SSD_7000 Vopak Site B4 Tank Farm

Response to Submissions Report

Client: Vopak Terminals Pty Ltd

18-Dec-2015

Figure 11 Port Botany Land Use Study – Cumulative Individual Risk Contours including postulated Future Development (1996)

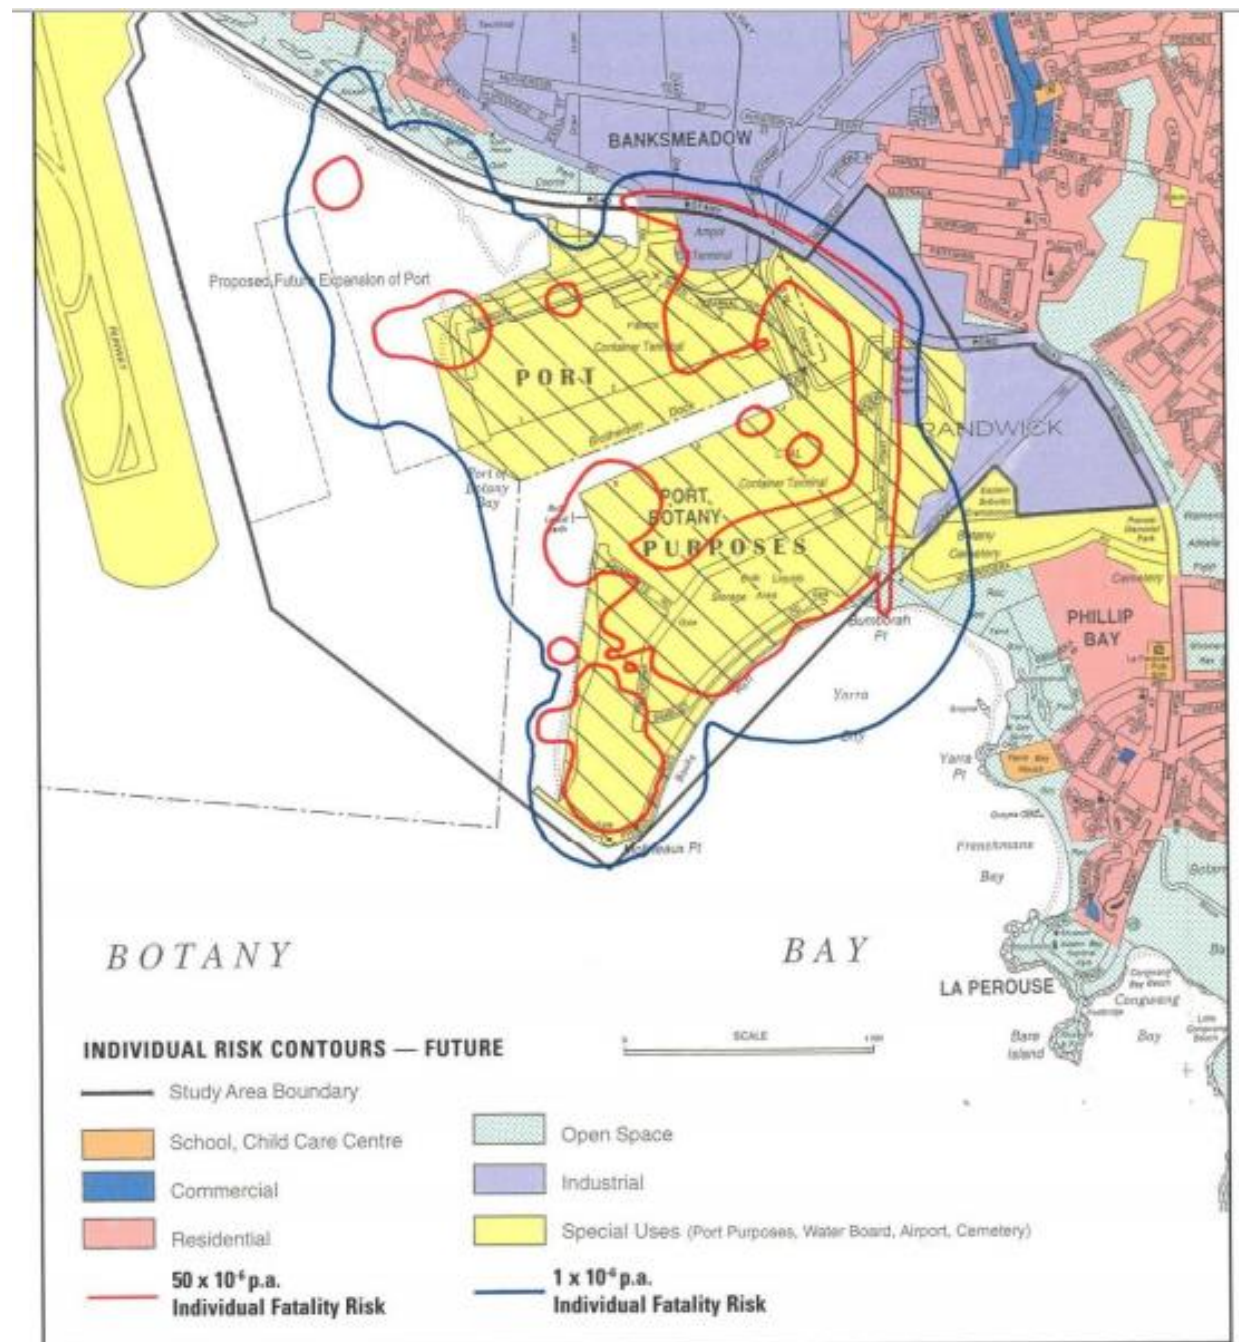
Needs to be updated with 30 year projections as part of NSW Ports 30 Year Plan

No.	Issue	Response	Relevant Section
		also required as part of the MHF Safety Case update.	
41	The hazard analysis needs to be updated to include 30 year projection as part of the NSW Ports 30 Year Plan.	The NSW Ports 30 Year Plan is a strategic guidance document that identifies likely land use and infrastructure requirements based on anticipated trade forecasts over a 30 year outlook. As the specific details of how port requirements will develop there would be a lack of accuracy in undertaking a hazard analysis based on possible development scenarios. It is more appropriate to undertake as detailed hazard assessment of projects as they are proposed so that the most appropriate management and risk mitigation measures can be implemented leading to improved risk reduction outcomes. It should also be noted that the Project specific hazard analysis included consideration of the Port Botany Land Use safety Study (DP&E, 2001). As this study predates the NSW Ports 30 Year Plan its recommendations have been included in the 30 Year Plan as appropriate. The Project is therefore considered to have appropriately considered the requirements of the relevant strategic planning documents particularly in relation to hazards and risk.	N/A

Drainage Plans

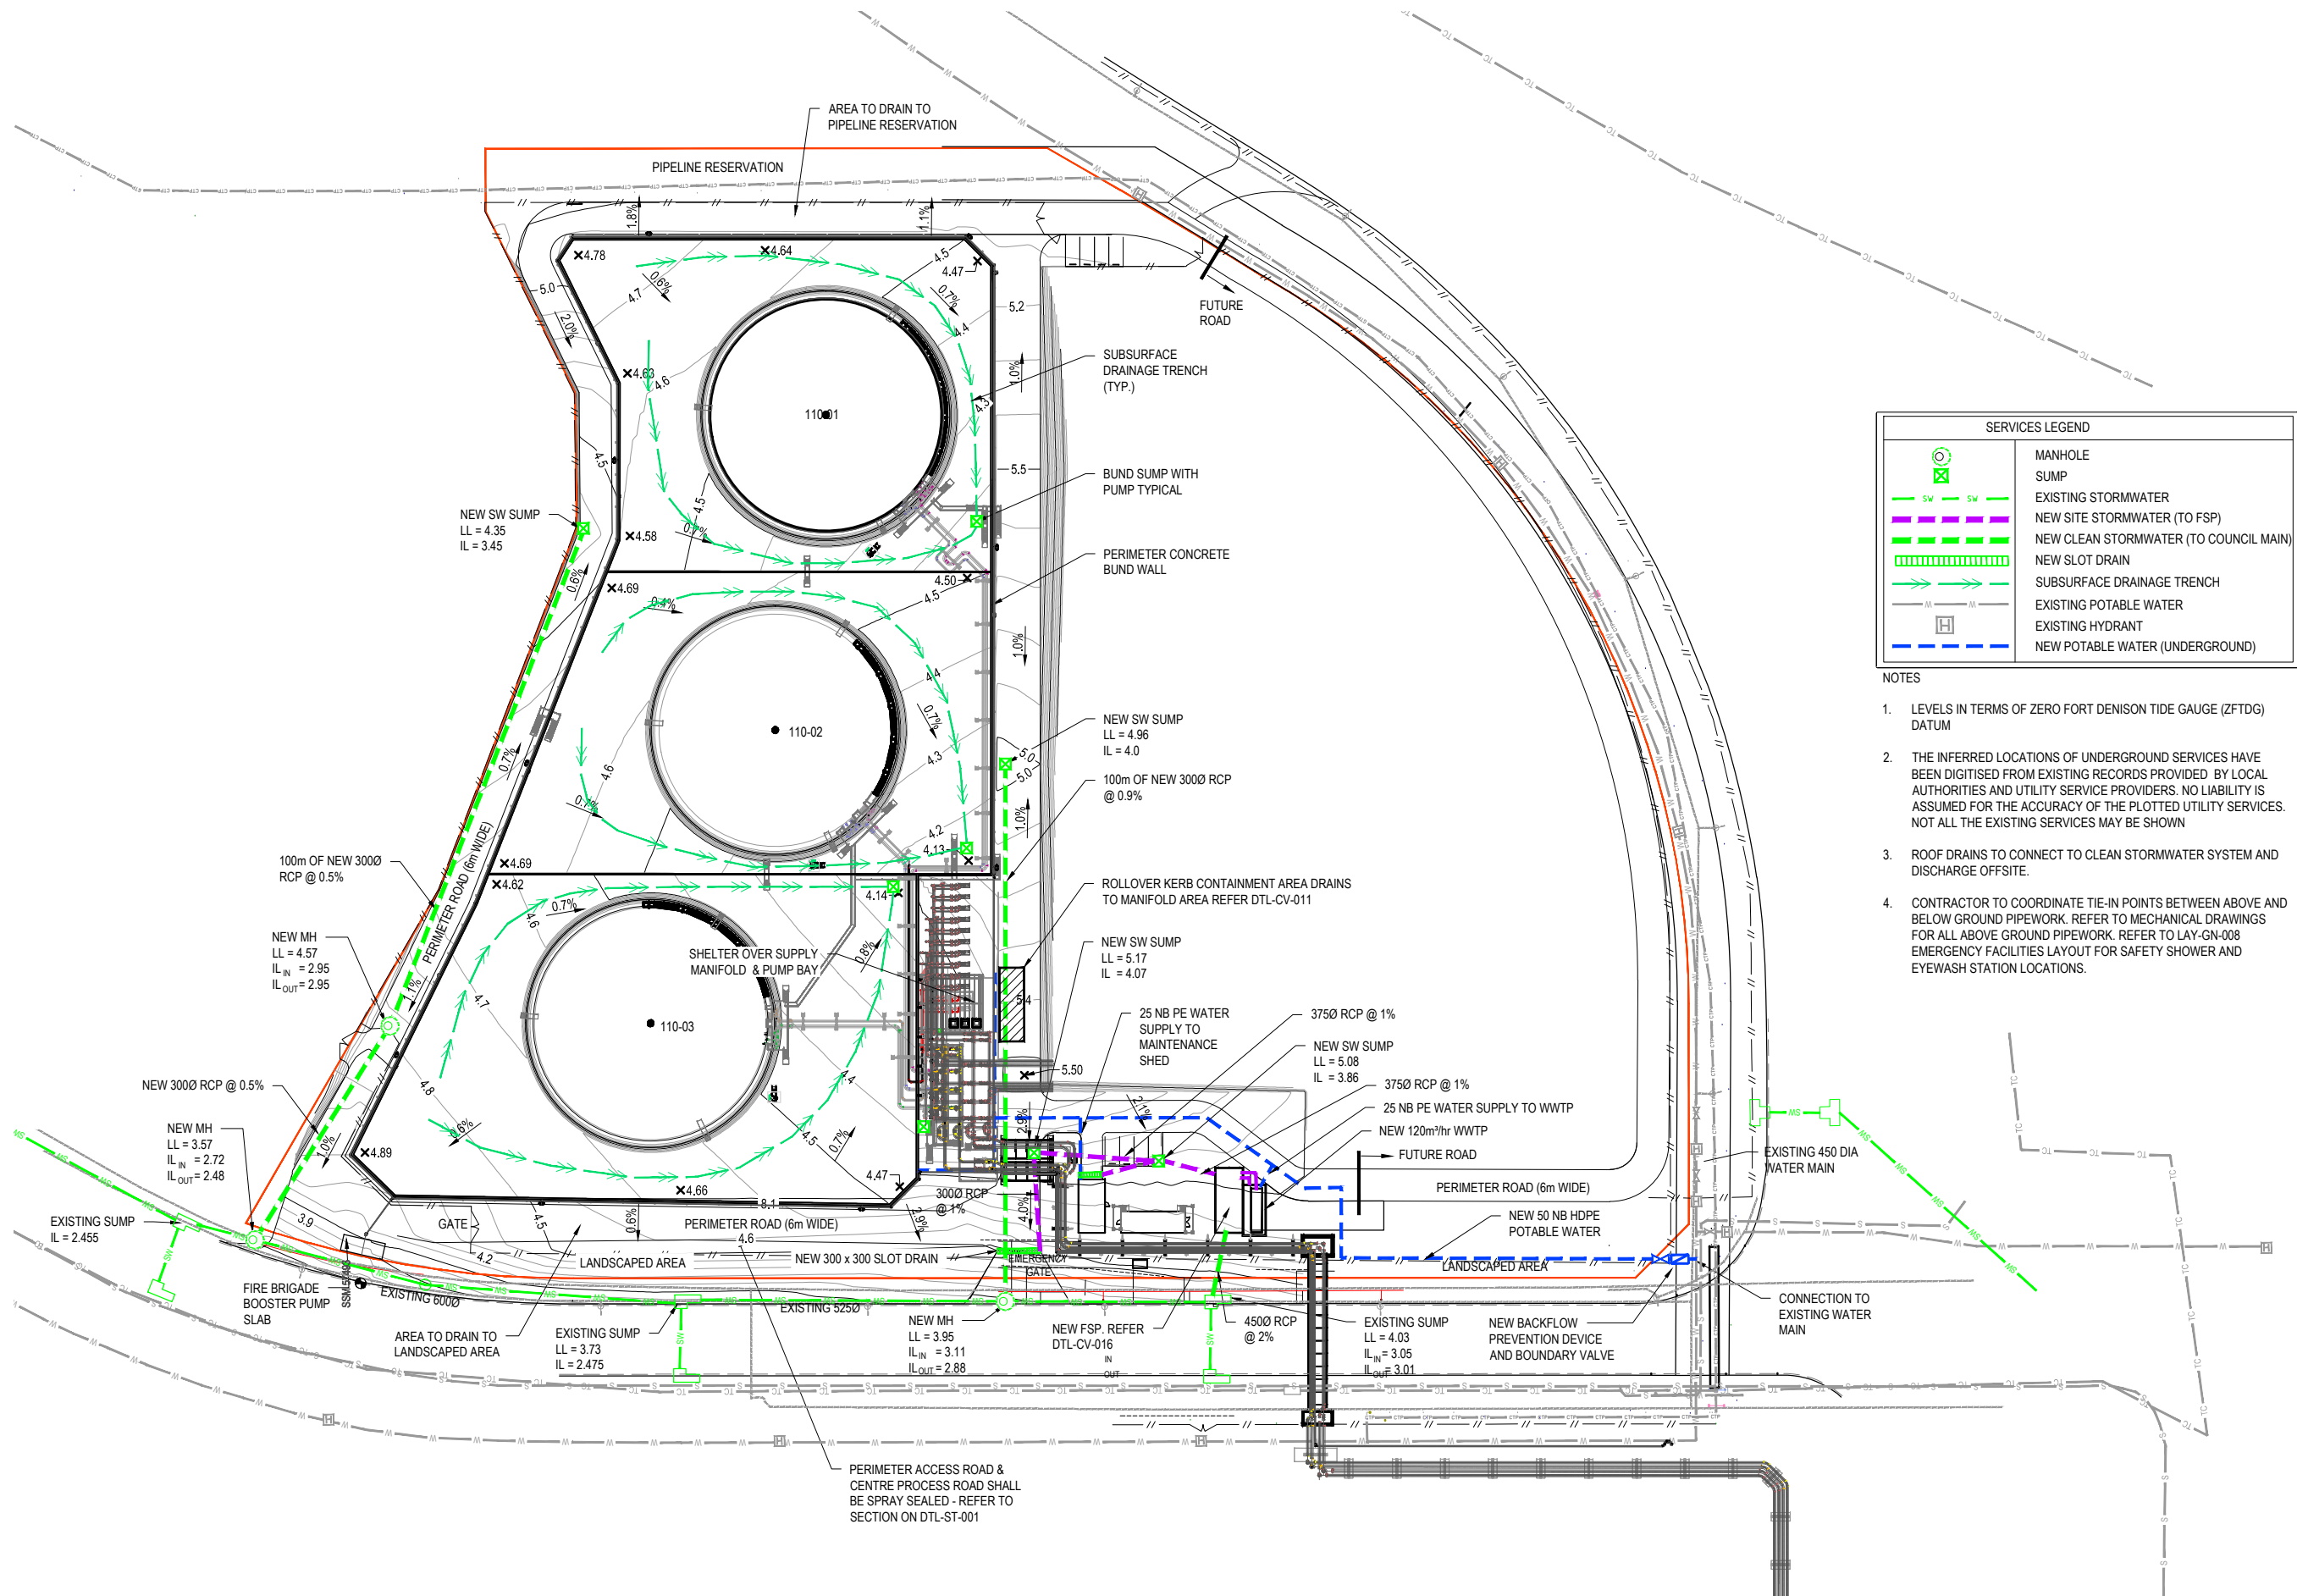
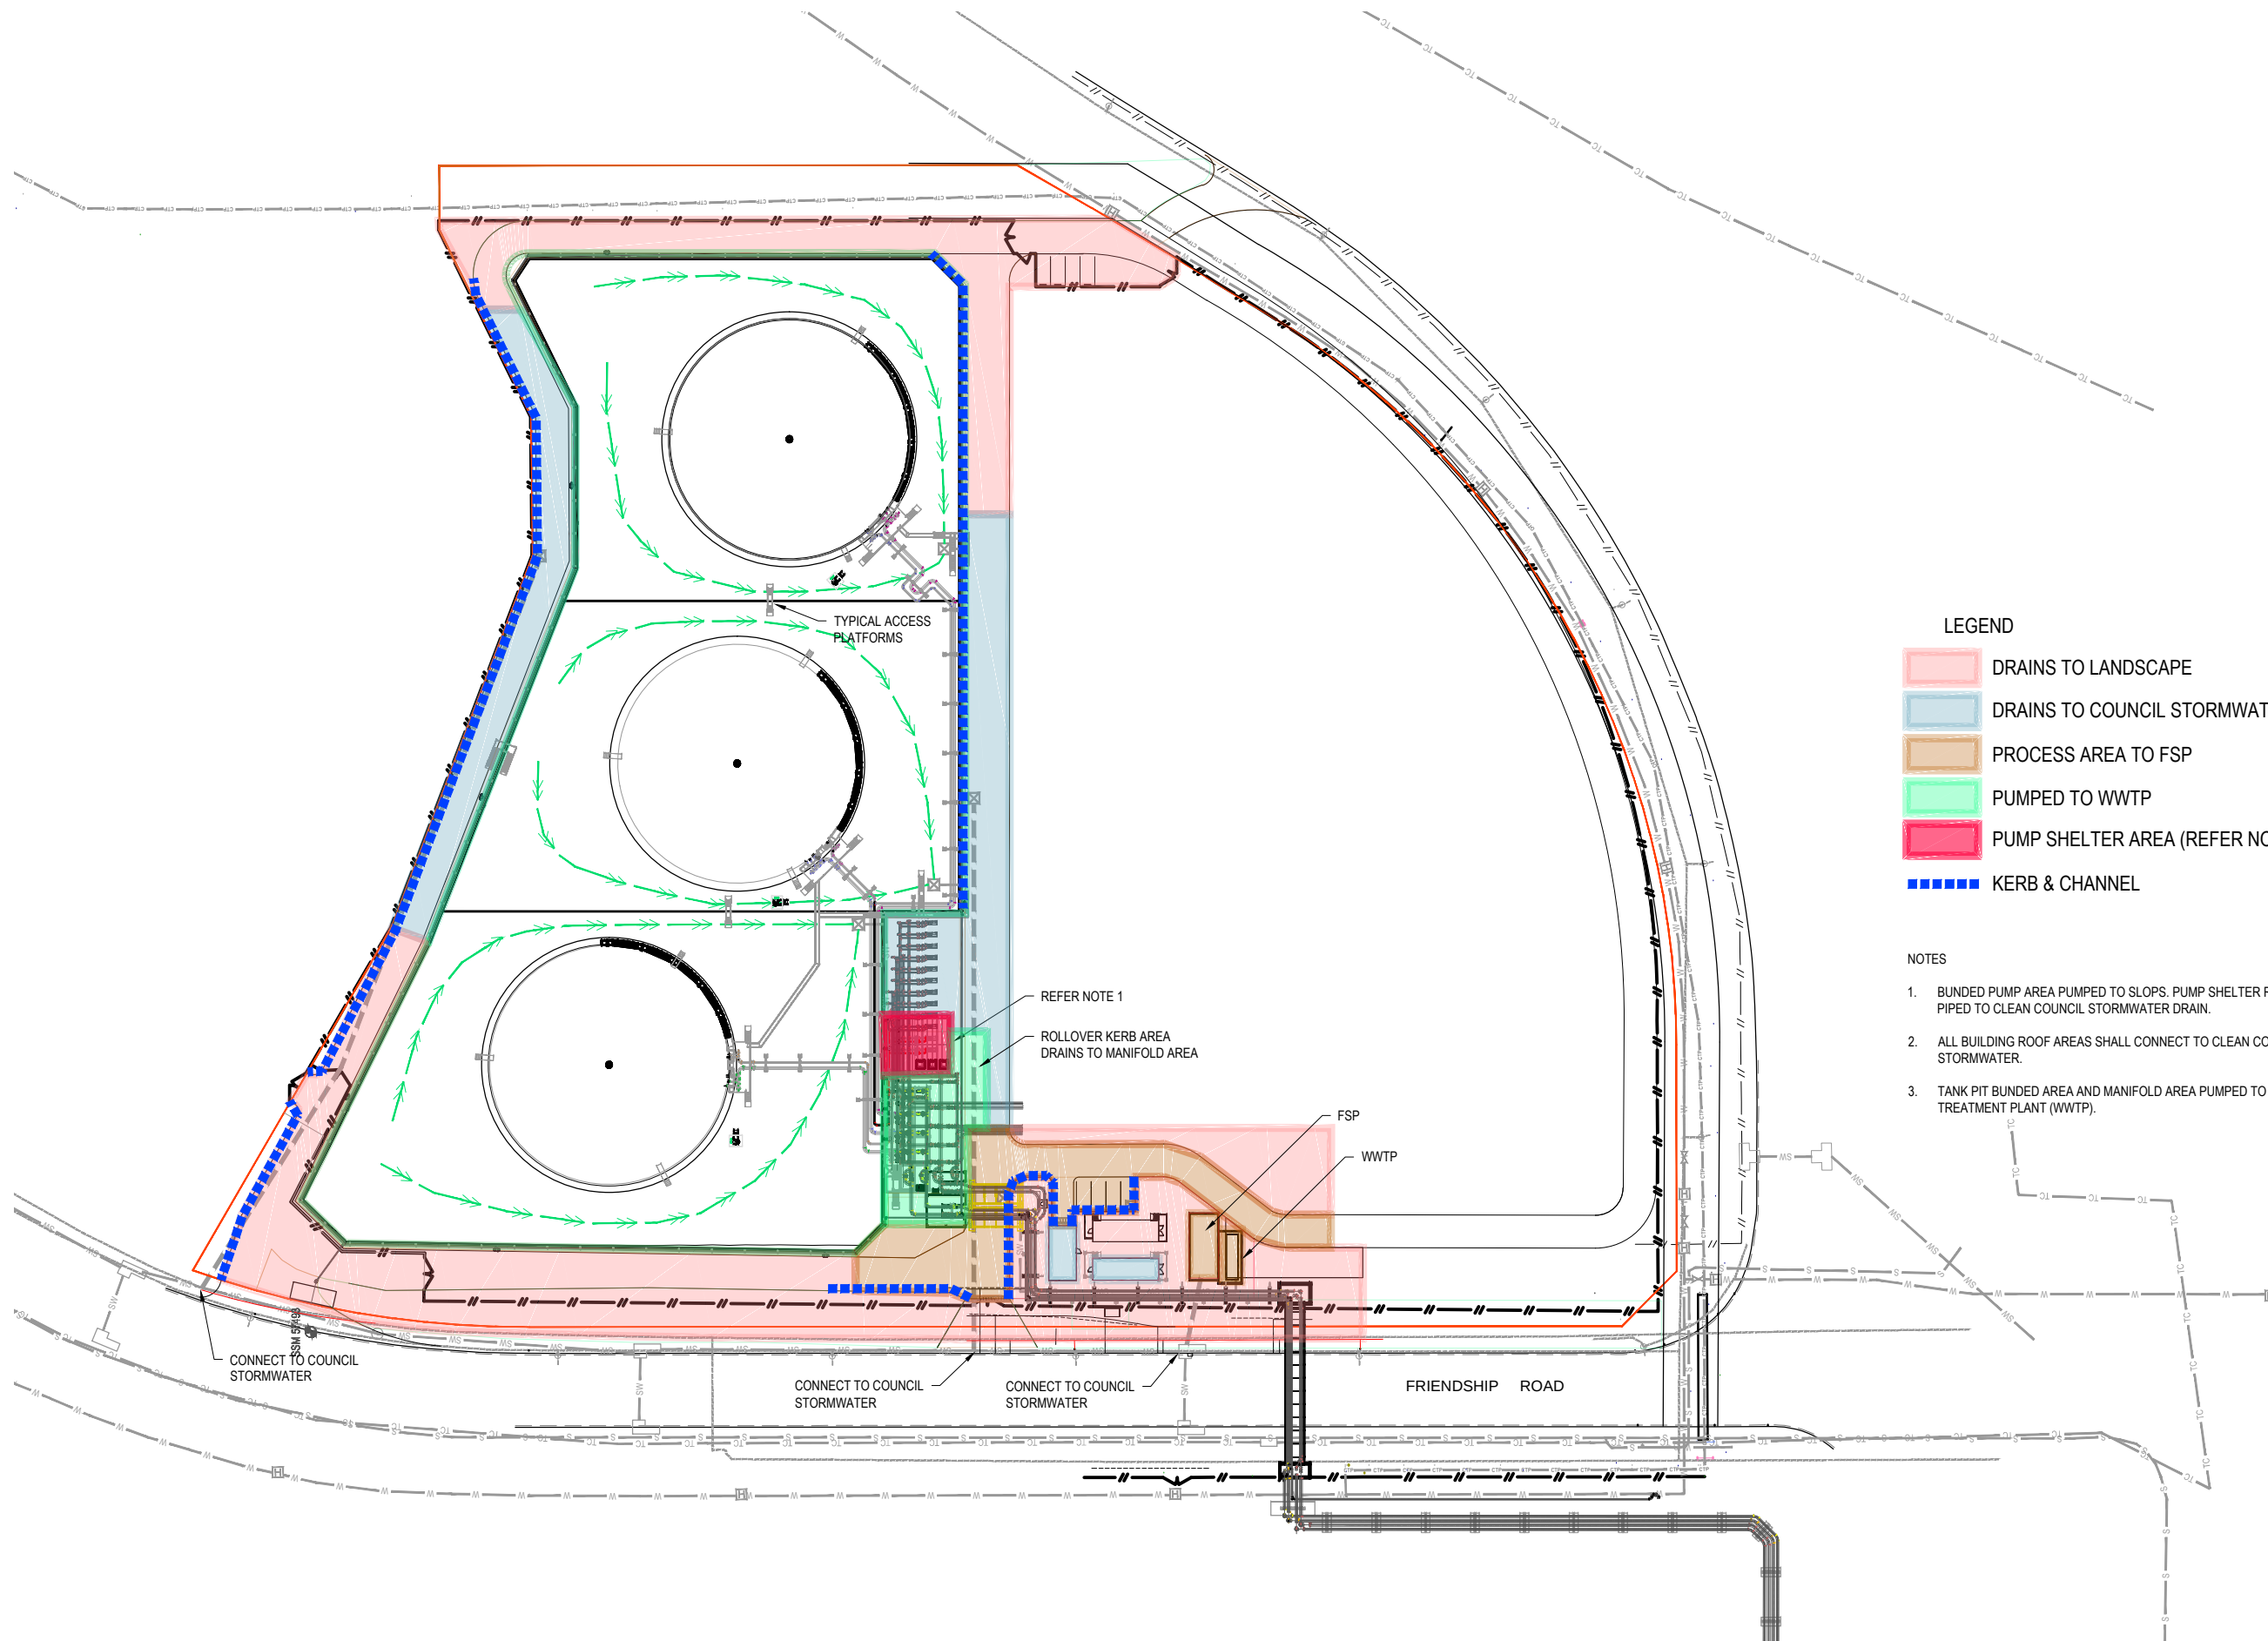
3	The design, construction and operation of the fuel storage areas should comply with the following requirements where applicable: a) A bund wall must be constructed around all work and liquid storage areas to prevent any spillage entering into the stormwater system. The bund area must provide for at least a volume equal to 110% of the largest containers stored and graded to a blind sump so as to facilitate	Vopak intends to design and construct the Project in accordance with the relevant regulation and standards. In regards to b) All bund areas will drain via treatment devices as indicated in (e), however clean stormwater areas will drain to onsite landscaping soak areas or direct to the	N/A

No.	Issue	Response	Relevant Section
	cleaning. b) A trafficable bund capable of preventing the escape of any pollutants into Councils Stormwater system must be provided to all access ways/exists from the development. c) Flammable and combustible liquids must be stored in accordance with AS 1940-2004- The Storage and Handling of Flammable and Combustible Liquids and relevant requirements of NSW WorkCover Authority. d) Prior to the storage of any dangerous goods on the premises a licence must be obtained from the WorkCover Authority and a copy of the licence must be forwarded to Council. e) Service and parking areas must be graded and drained to a stormwater treatment device capable of removing litter oil grease and sediment prior to discharge to the stormwater system complying with relevant EPA requirements and conditions of consent. f) A permanent record of receipts for the removal of both liquid and solid waste from the site shall be kept and maintained up to date at all times. The records are to be made available to EPA and Council Officers upon request.	NSW Ports street underground stormwater drains in accordance with NSW Ports agreements. Reference is made to Appendix E showing indicative drainage plans.

- **Appendix E** provides indicative drainage plans showing both internal bund drainage and external (clean water separation) drainage.
